FORT HOOD SOLAR TOTAL ENERGY PROJECT
Technical Support and Systems Integration

First Semiannual Report for May 1–October 31, 1978

FORT HOOD SOLAR TOTAL ENERGY PROJECT
Technical Support and Systems Integration

FIRST SEMI-ANNUAL REPORT
FOR THE PERIOD
1 MAY 1978 - 31 OCTOBER 1978

Thermal Load Displacement as a Function of Collector Area

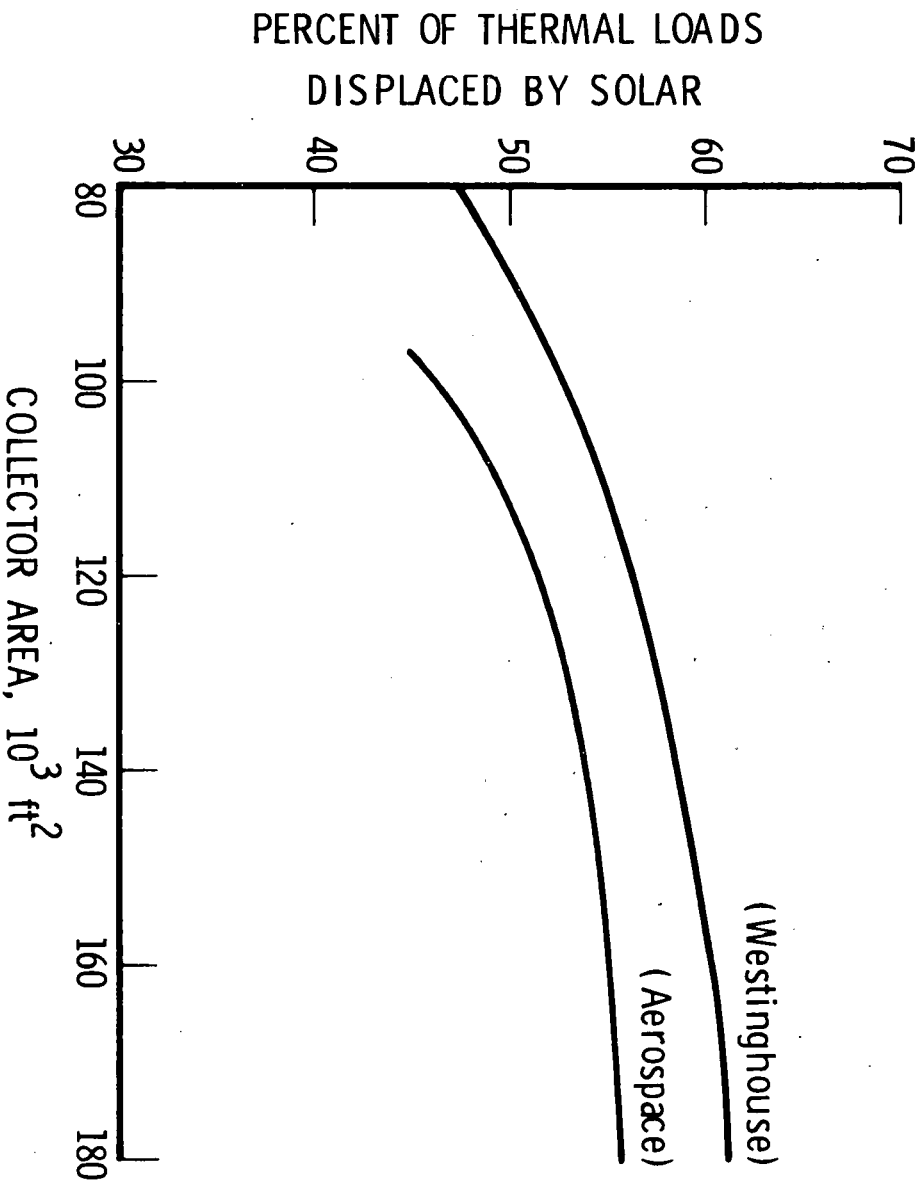
Westinghouse used a computer simulation to generate a curve of Percent of Thermal Load Displacement versus Collector Area. DOE/ALO asked Aerospace to conduct an independent analysis to validate the general characteristic of a decreasing return for incremental increases in collector area for large field sizes. A product of the Aerospace calculation is plotted on Chart 2-3 along with the Westinghouse curve and validates the characteristic of the Westinghouse result. The Aerospace simulation assumed a simplified STES model and hence does not exactly duplicate the Westinghouse curve.

For the Aerospace analytic model, the thermal loads were taken from Reference 2. For the curve shown in Chart 2-3, storage was assumed to be depleted at 6:00 a.m. each day. The differing demands of the heating, cooling, and transition seasons were incorporated to simulate a full year of operation. Additional curves were generated with the model, assuming different storage capacities and depletion times and are included in a Topical Report (Reference 1).

From the Westinghouse curve, it can be seen that a minimum field size for displacing 50 percent of the thermal load is about 90,000 ft² which establishes a lower bound.

Site Plan Proposed for the PTA at West Fort Hood

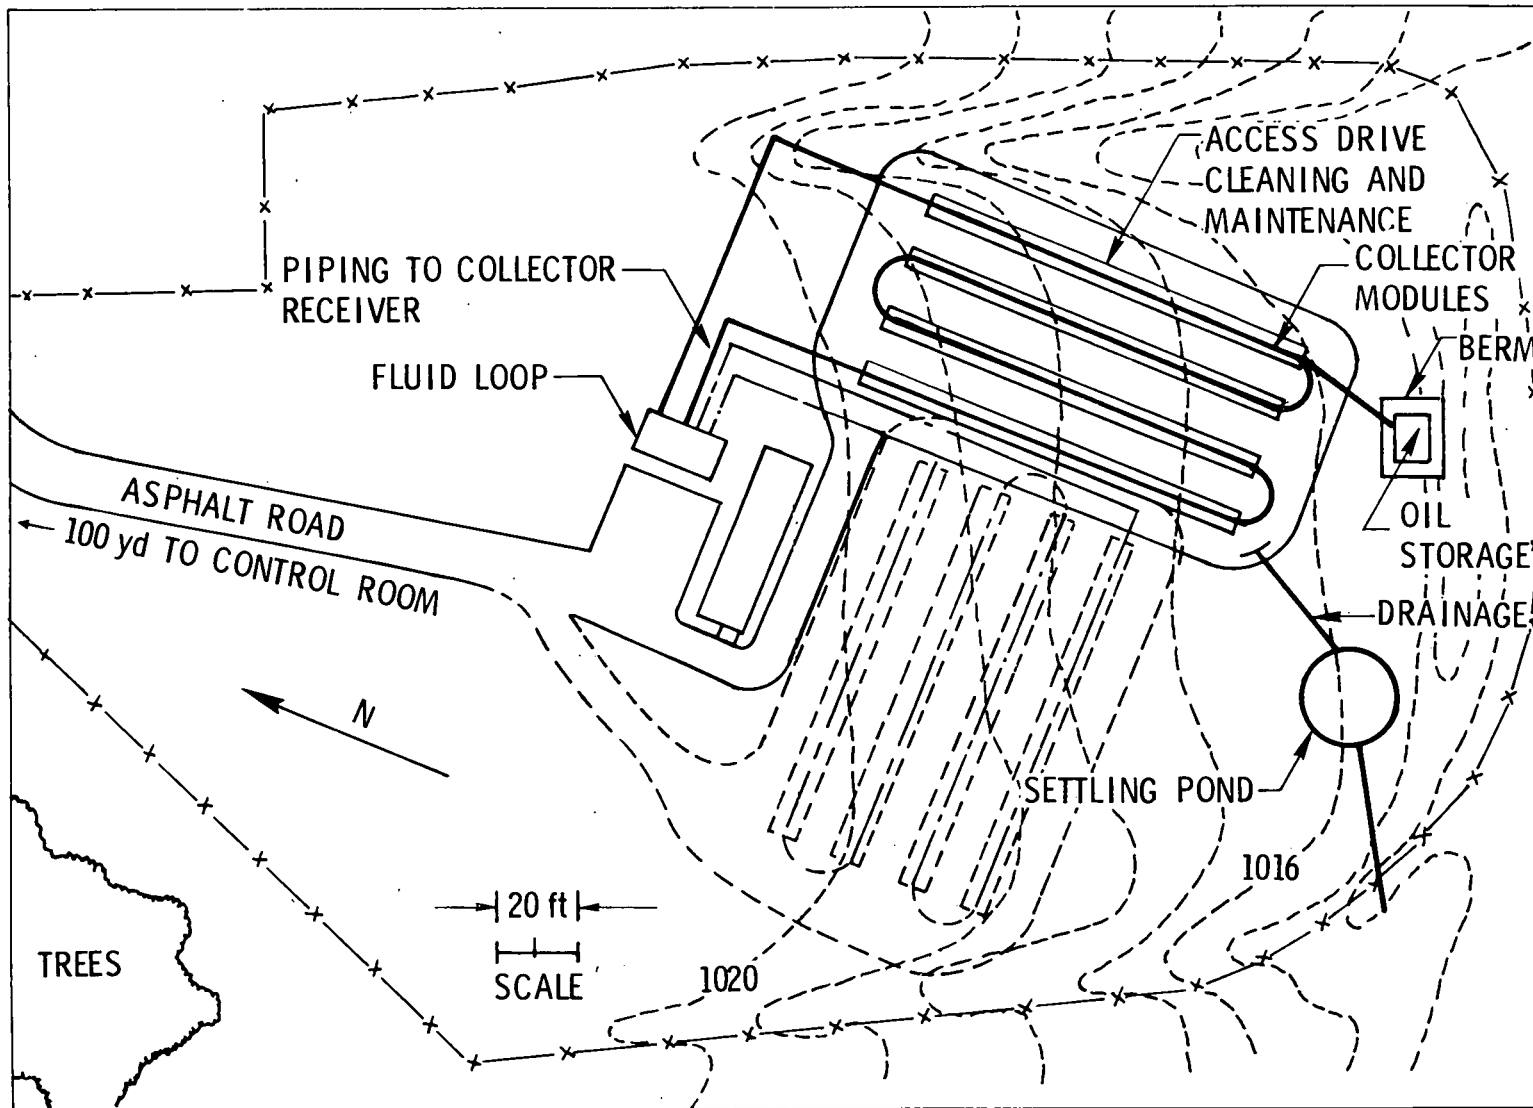
The PTA layout recommended by ATU if it were located at West Fort Hood is shown in Chart 2-9.

The initial plan by ATU for installing the PTA at the West Fort Hood site involved a serpentine arrangement of the collectors in order to accommodate the equivalent of a full collector row (nominally 400 ft) and still fit within the existing fenced enclosure. That layout exemplifies some of the objections Aerospace found with that location: the serpentine arrangement unavoidably introduces an excess of plumbing (and thermal mass) since the row segments must be interconnected.

An Alternate PTA Site Plan for West Fort Hood

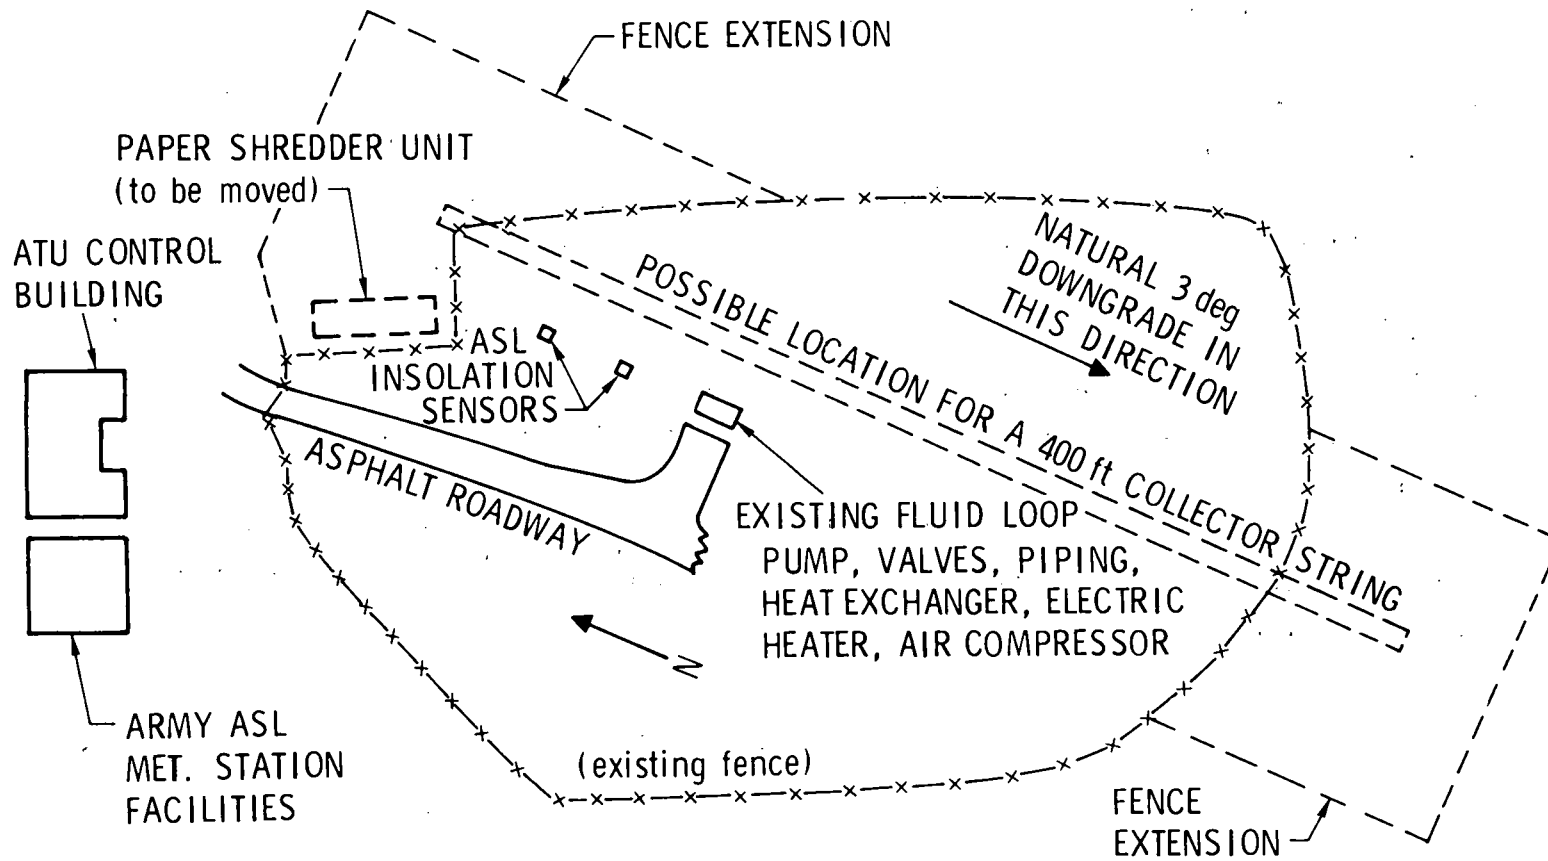
As part of its independent study of the PTA siting issue, Aerospace inspected the facilities at West Fort Hood and verified that with fence extensions, a full 400 ft collector row, could be installed at that site as indicated in Chart 2-10.

As an Action Item from the May 18-19, 1978 Design and Project Review, ATU conducted a study to trade off the two potential locations and to supply data and rationale to support their results. The ATU conclusion was to retain the West Fort Hood site but to modify the site plan to accommodate a continuous line of collectors.

Aerospace noted the absence of wind obstructions and of any serious shadow-producing structures. Further, it was determined that Army Atmospheric Sciences Laboratory insolation sensors and data recording equipment were still available at the site for use by ATU so that a solar meteorological station proposal by ATU for use with the PTA was probably not needed.

Collector Field Configurations Considered for Fort Hood

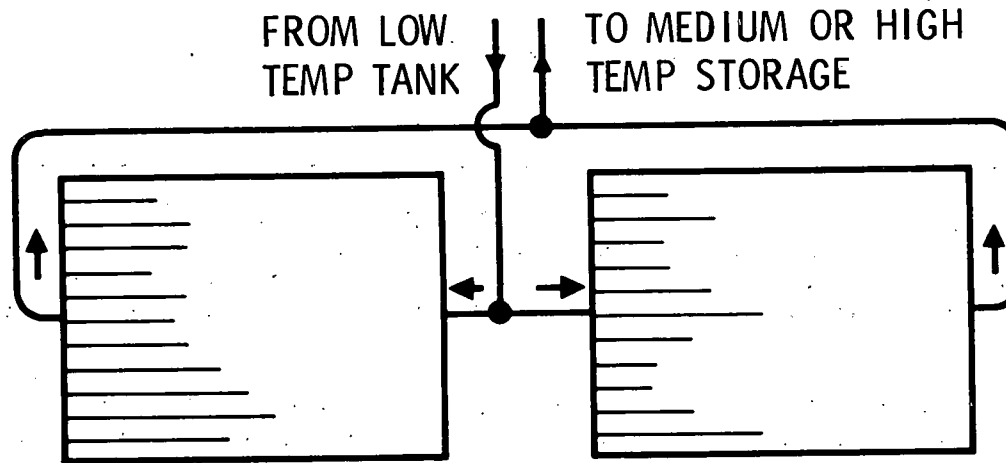
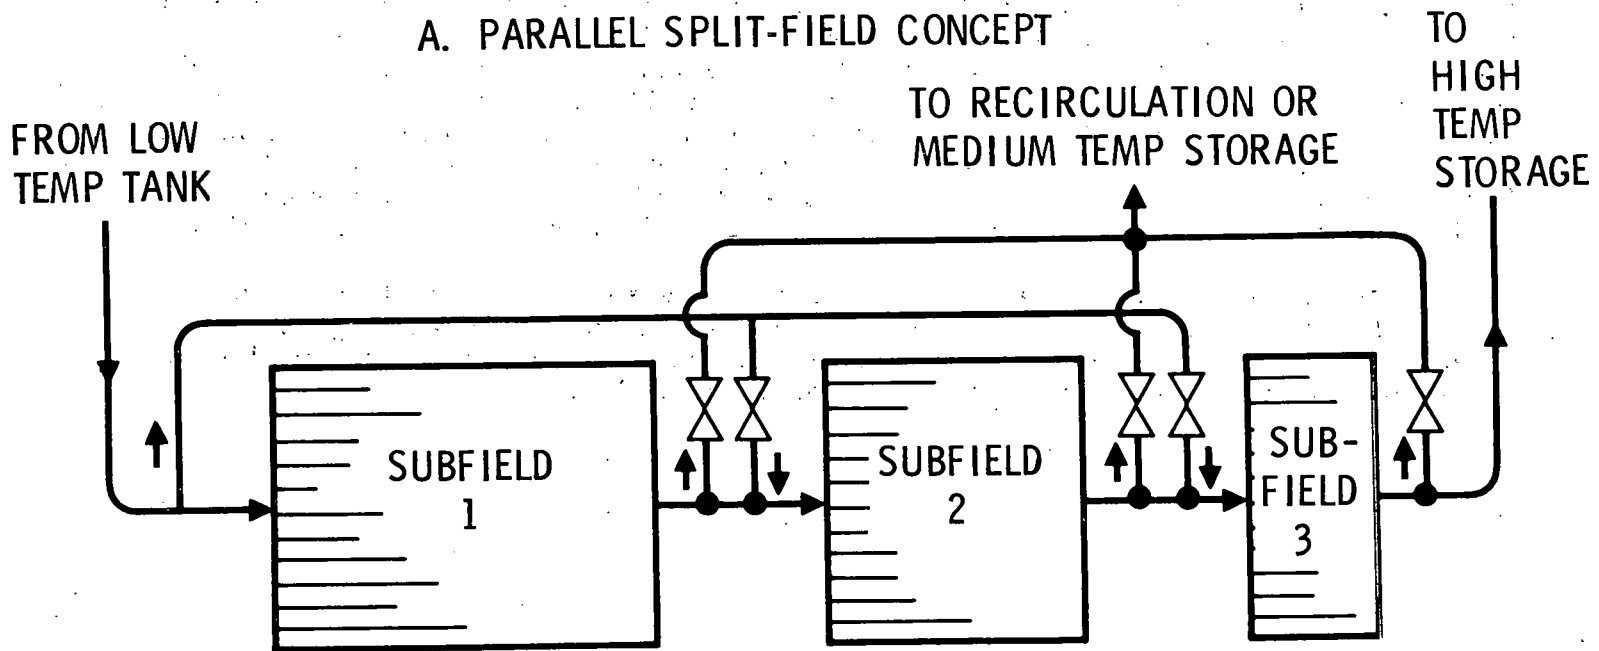
Following the August 3-4 Design Review, Aerospace was asked by DOE to investigate the proposed change from a parallel split-field concept with conventional feedback control to the series field concept with feedforward control. Westinghouse claimed that the large transport lag associated with the first concept would create oil overtemperature conditions when abrupt insolation transients occur. In the new concept, the flow of heat transfer oil is basically serial through the three subfields except that provision is made for "tempering" the oil exiting subfields 1 and 2 with oil from the low temperature tank before it enters the subsequent subfield.

The principal advantages claimed for the new design are that it prevents the development of overtemperature conditions and allows continued operation of the field during periods when insolation levels would be considered below threshold for the old concept. Furthermore, there is a significant reduction in the quantity of control valves and thermocouples required.

Analysis of New Collector Field Design

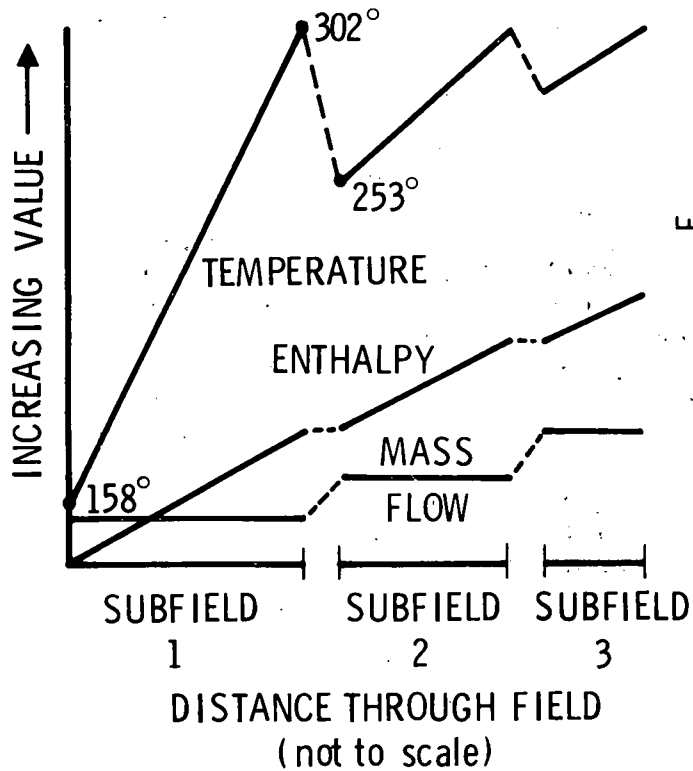
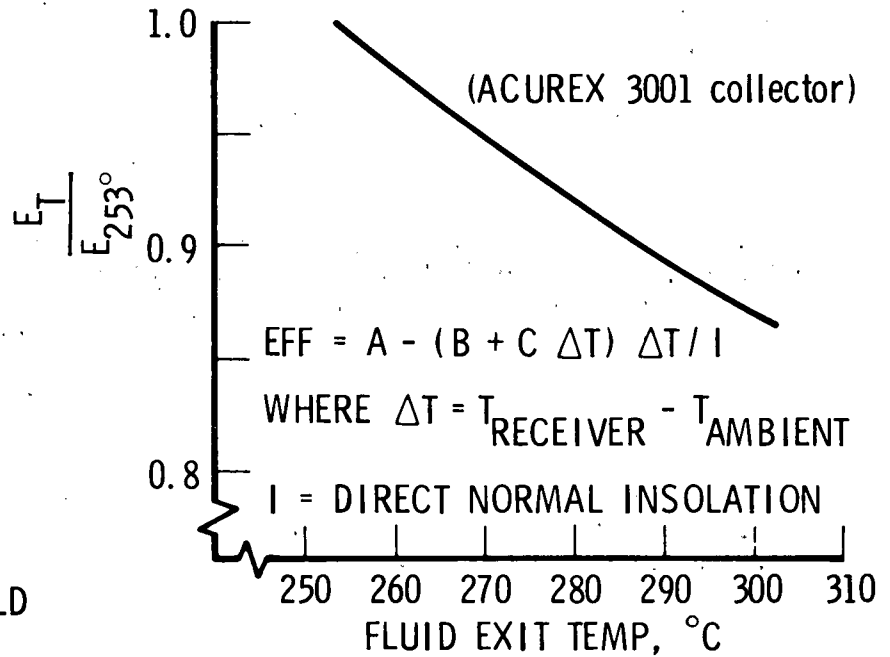
Aerospace reviewed the results of Westinghouse static performance calculations for the new field design and analyzed the new design from the standpoints of thermodynamic efficiency and temperature controllability. Technical interchange meetings primarily addressing this topic were held with Westinghouse on August 21, 1978 at El Segundo and October 4, 1978 at Pittsburgh.

The predicted behavior of the thermodynamic variables in the new field design is shown qualitatively in the graph on the left-hand side of Chart 2-13. Under full sun conditions the oil in subfield 1 is heated (from 158°C) to 302°C, then mixed with a selected flow of cooler oil to reduce its temperature to 253°C. In that mixing action there is theoretically no loss in energy content of the combined oils referenced to oil at 158°C. However, if subfield 1 attained a temperature of only 253°C, it would have been achieved at a higher collection efficiency. That point is illustrated in the graph of normalized collector efficiency on the right-hand side of the chart. Aerospace calculated that the overall reduction in efficiency translates into a slight increase in collector area (3.7 percent) to collect the same number of Btu's as the parallel split-field design.

In spite of this liability, after all aspects of the issue were considered, a provisional go-ahead was recommended for the new design pending results of Westinghouse transient analyses. Its apparent principal advantage is the ability to prevent the heat transfer fluid from overheating under any foreseen conditions.
